Environmental Planning Commission

Agenda Number: 3
Project #: 2021-005301
Case #: SI-2021-00452
Hearing Date: July 15, 2021

Supplemental Staff Report

**RE: DUTCH BROTHERS MAJOR AMENDMENT 7 BAR- EPC
RESPONSE TO COMMENTS PR-2021-005301/SI-2021-00452
3615 HWY 528, ALBUQUERQUE NM 87114
ZONE ATLAS PAGE A-14-Z**

ENGINEER'S SEAL	NM 528 AND ELLISON	DRAWN BY LN
	3615 HWY 528	DATE 07/01/2021
	SITE PLAN - EPC	DRAWING 2014069-SPE
		SHEET # C1
		JOB # 2020091

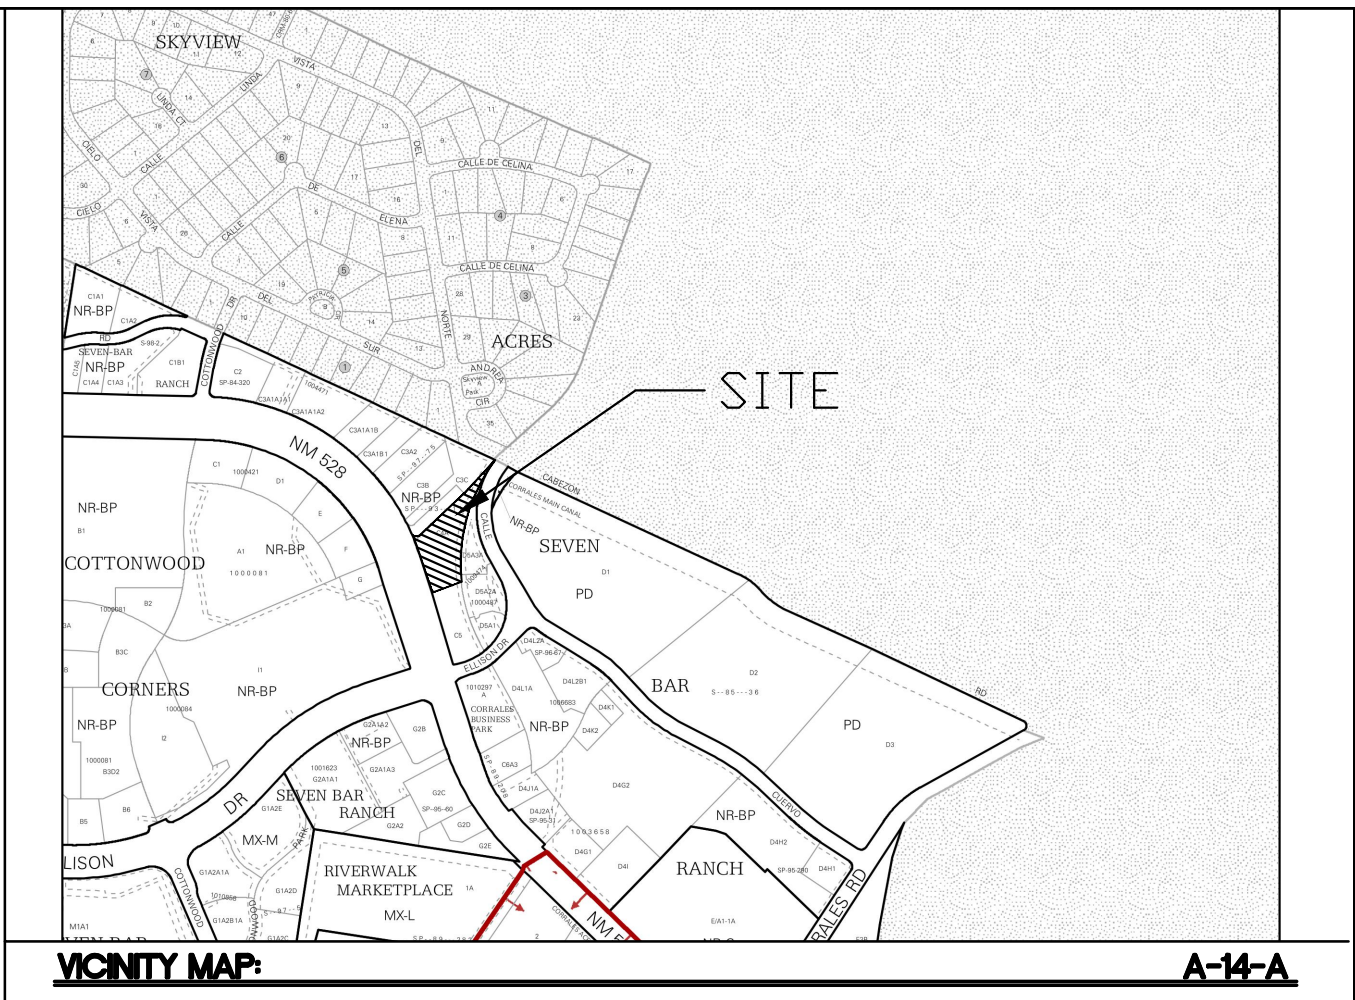
3. Procedural Clarification- Sheet C-1:

A. A note shall be added to indicate that the site plan shall supersede the 2017 site development plan for these same geographic boundaries.

B. A note shall be added to indicate that the Phase II building will go through the DRB process (at which time a TIS will be required).

D. Provide all sidewalk widths on plan. A 6-foot ADA pathway shall be established from the main building to the right-of-way and from the handicapped spots to the main building.

E. Use keyed notes to call out all curb ramps on the plans. Provide curb, curb ramp, and sidewalk details. The sidewalk detail shall indicate a 2% maximum cross-slope.

- F. Call out curb on the plan, and call out all curb radii. A minimum 6" to 8" high curb is required for separation between parking and sidewalk or landscaped islands.

- G. The bike rack for the Dutch Brothers shall not obstruct the ADA pathway. Provide dimensioning for the bicycle spaces and adjacent pathway to make sure this will work.

- H. Label "No Parking" at the back of the van accessible aisles, and dimension all van accessible aisles on the site plan.

Response: Revisions made to site plan notes section of sheet C1 note 1.

Response: Revisions made to site plan notes section of sheet C1 note 2.

Response: Acknowledged, Site plan dimensions on sheet C1 indicate Phase 1 Side setbacks are to be 10' (East) and 65' (West).

Response: Revisions made to all crosswalks on the site plan on sheet C1 to be consistently 9' wide. Keyed note 19 also specifies a 9' wide cross walk width.

Response: 6' ADA paths are shown on the site plan sheet C1.

Response: Keyed notes indicate all infrastructure as shown on the site plan sheet C1. Sidewalk detail shown on sheet C2.1 indicates a max cross slope of 2%.

Response: Keyed notes indicate all curbs as shown on the site plan sheet C1 as well as curb radii.

Response: Dimensions shown near the bike rack location located on the site plan, sheet C1; indicate that there is adequate space for an ADA path.

Response: "No Parking" markings and dimensions are shown on the site plan sheet C1.

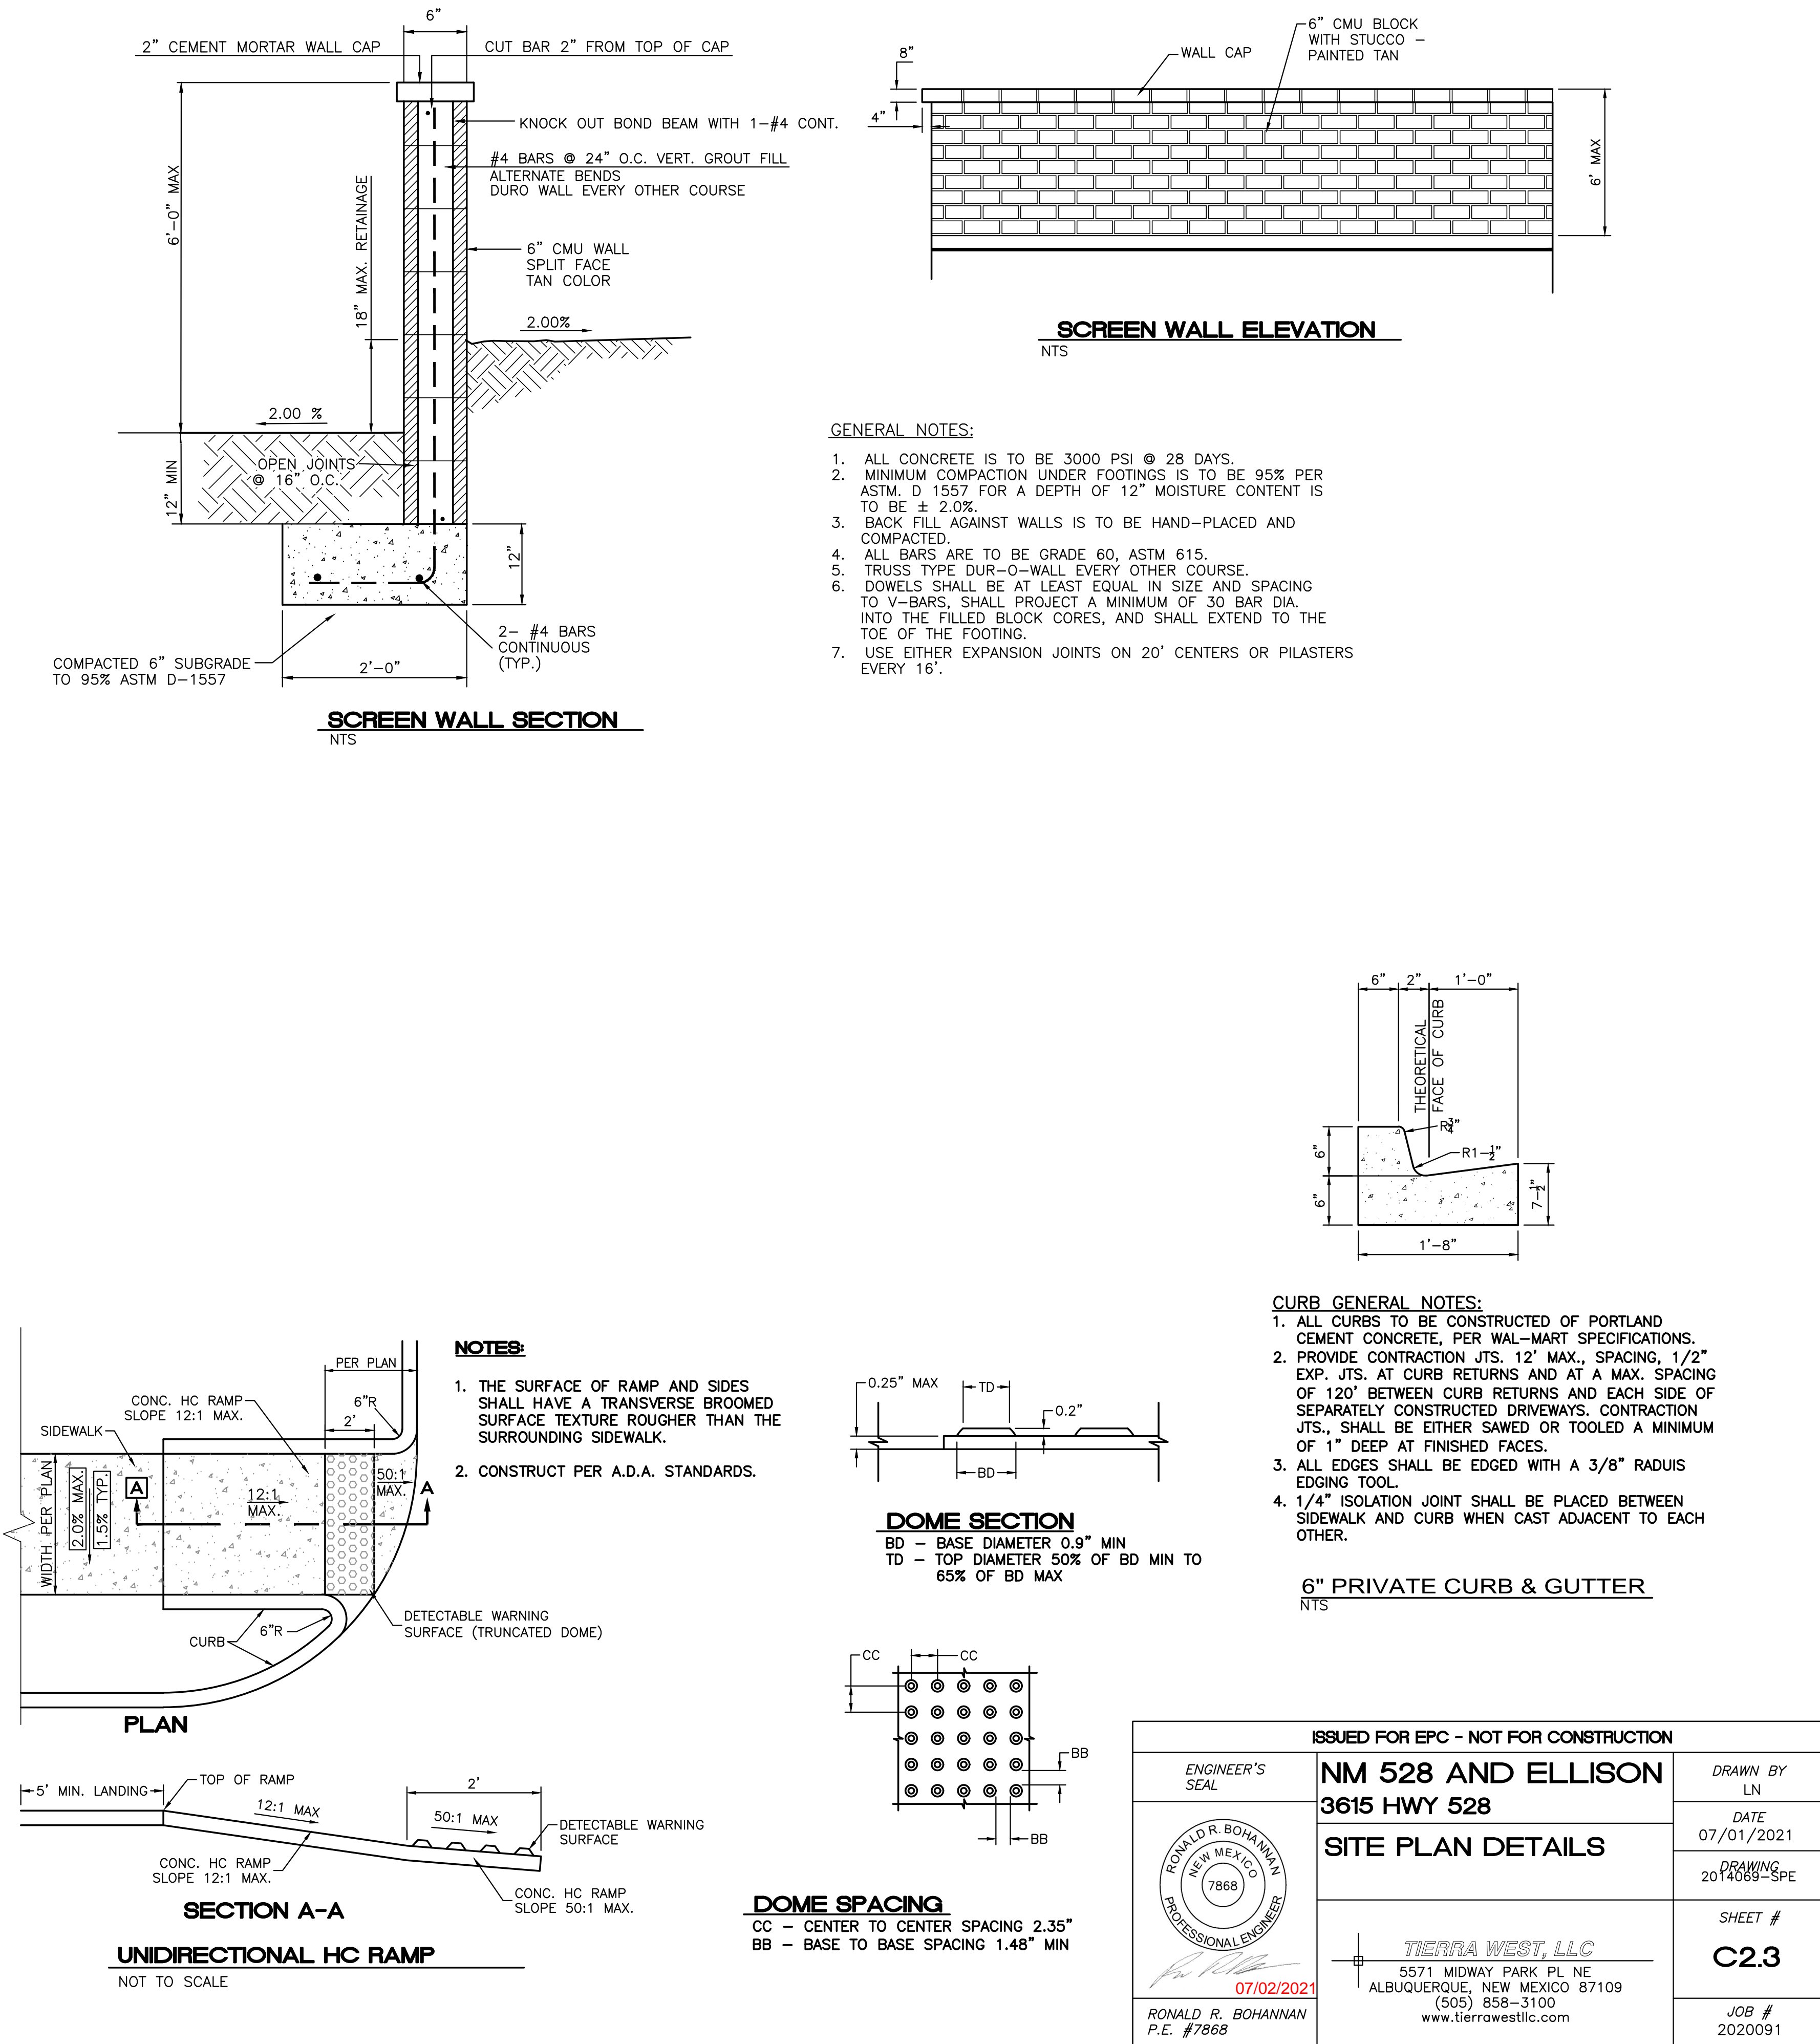
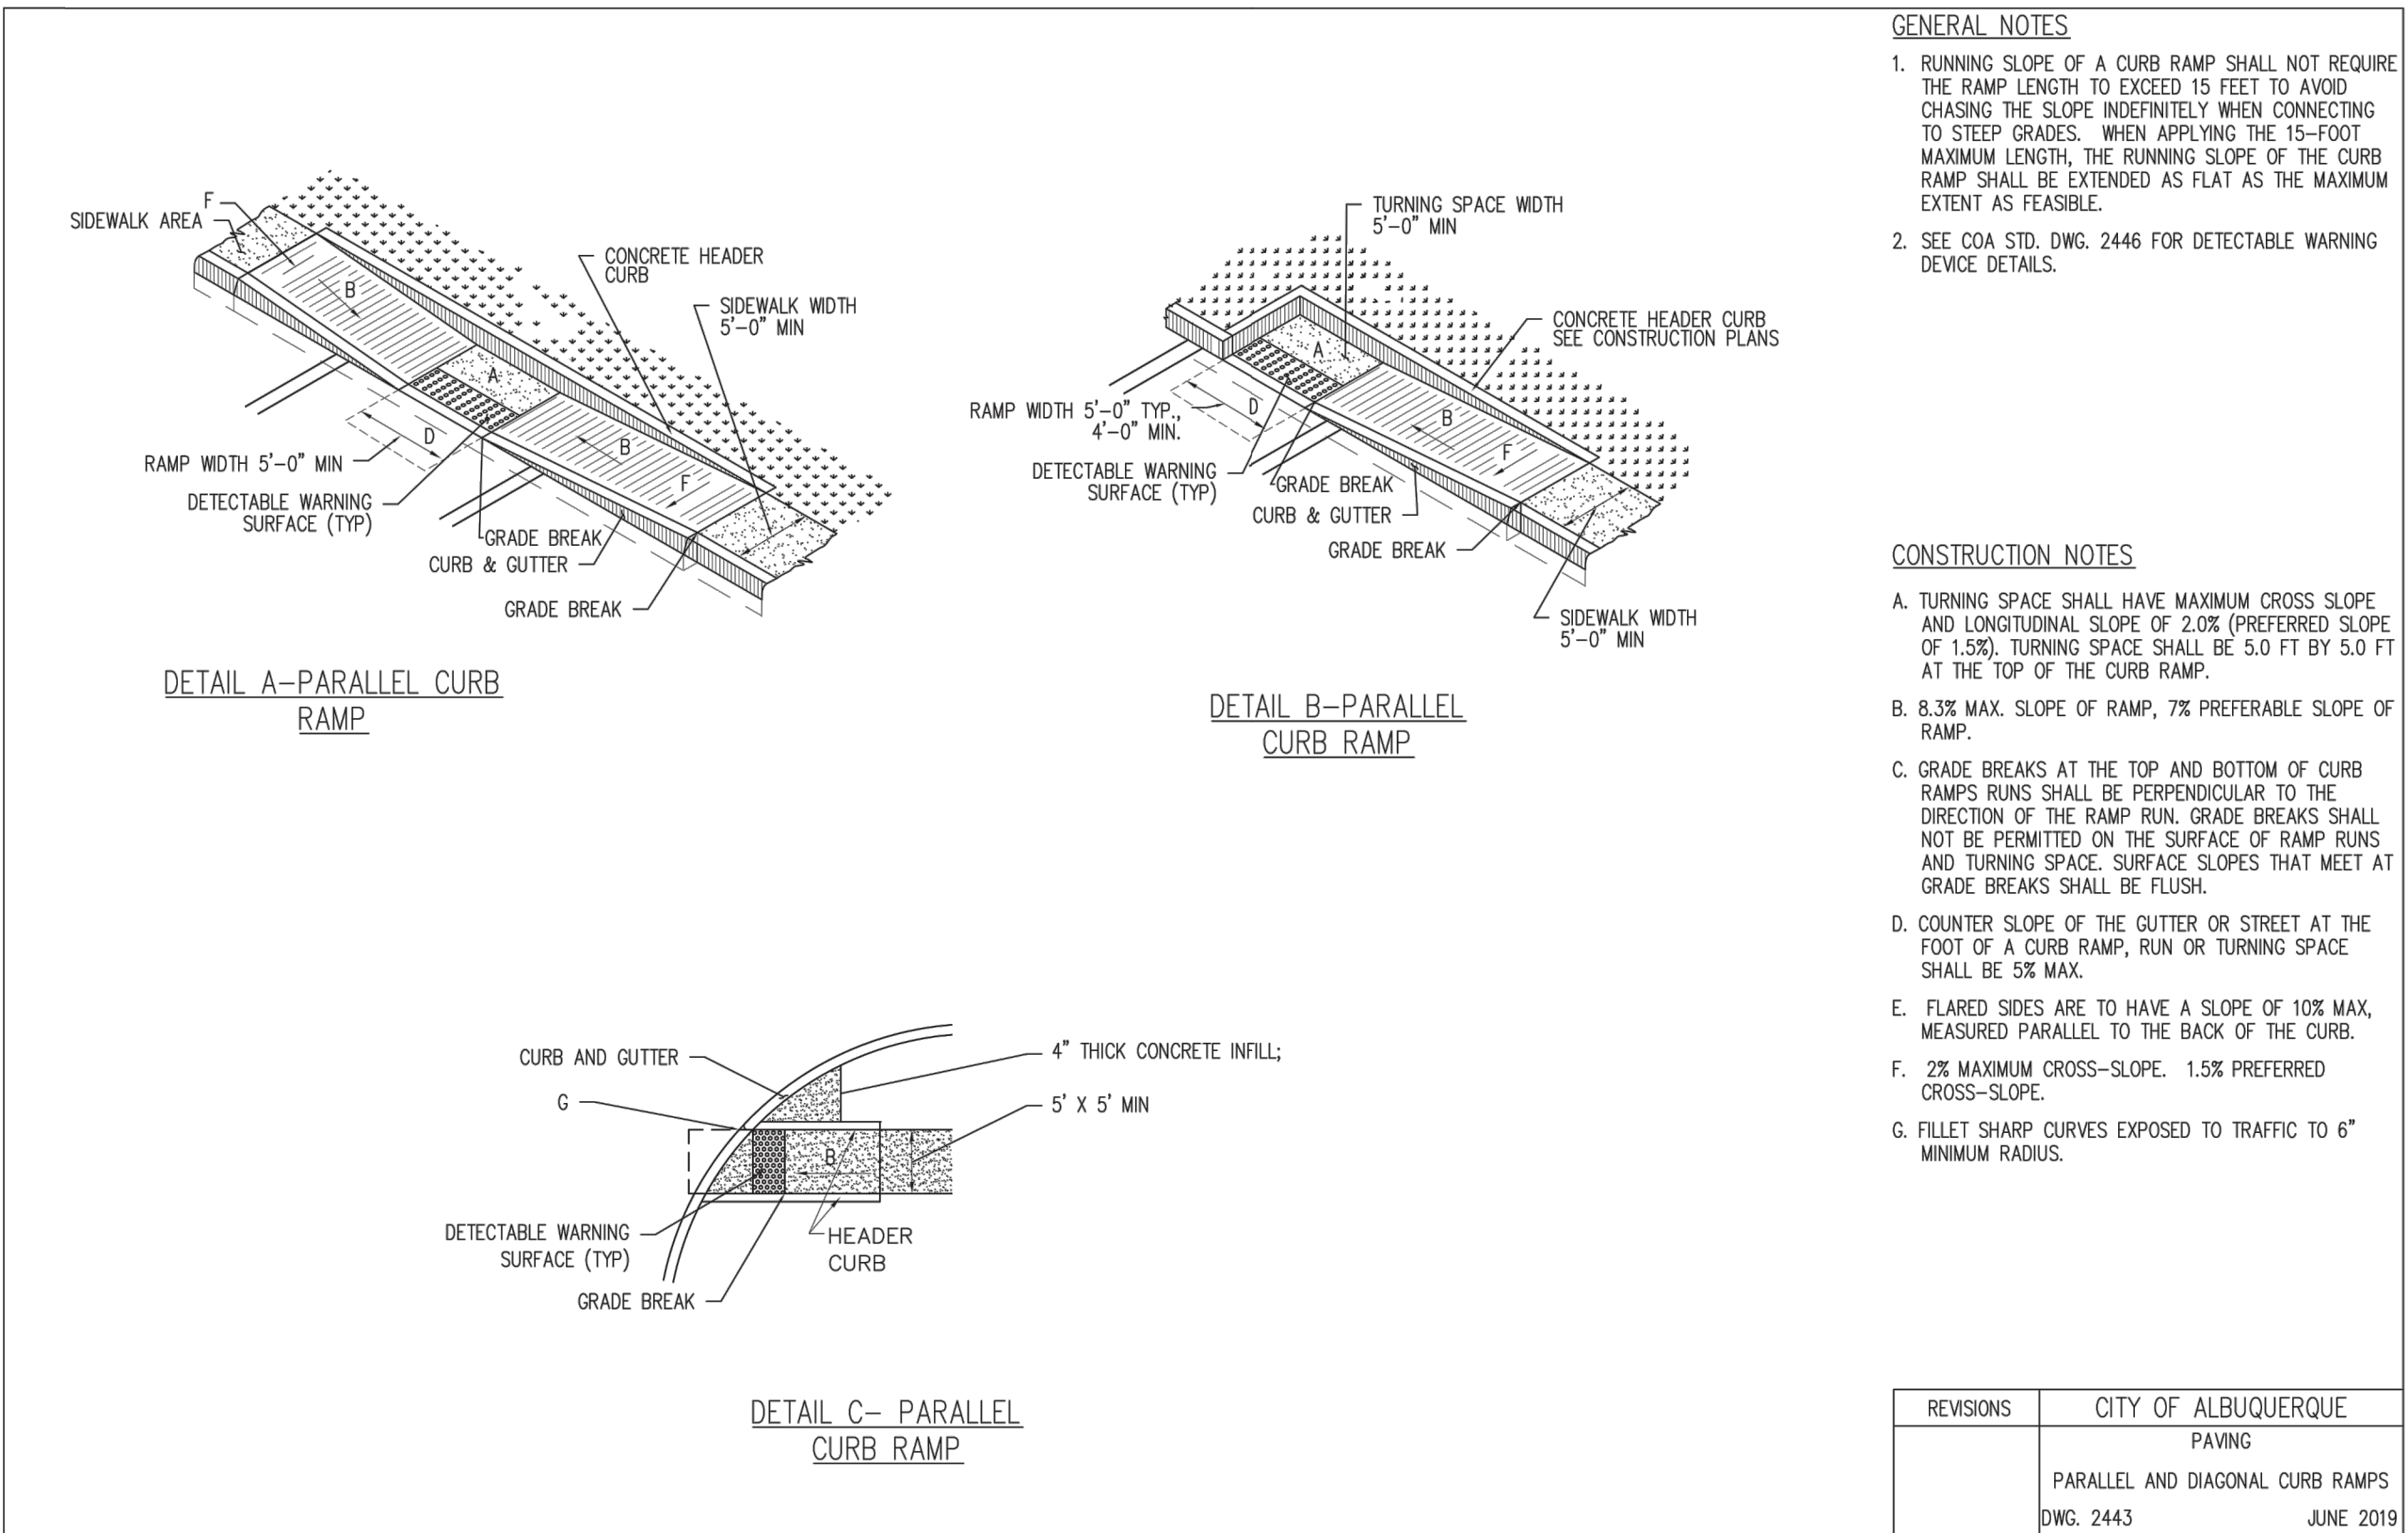
B. The landscaping calculations shall be revised to use the gross lot area specified on the main site plan (Sheet C-1), which is 86,684 sf.

A. Additional landscaping, including trees, shall be added to the area near the proposed detention pond to meet the requirement (see A, above) and to help screen the pond and the drive-thru lanes.

Response: Total landscape area provided is 18,571 sf. 15% of net lot area is 12,358 sf. Calculations are provided on the landscaping plan sheet LS-01.

Response: Revisions to calculations made on landscaping plan sheet LS-01.

Response: Revisions made to landscaping plan sheet LS-01.

Response: Revisions made to landscaping plan sheet LS-01.
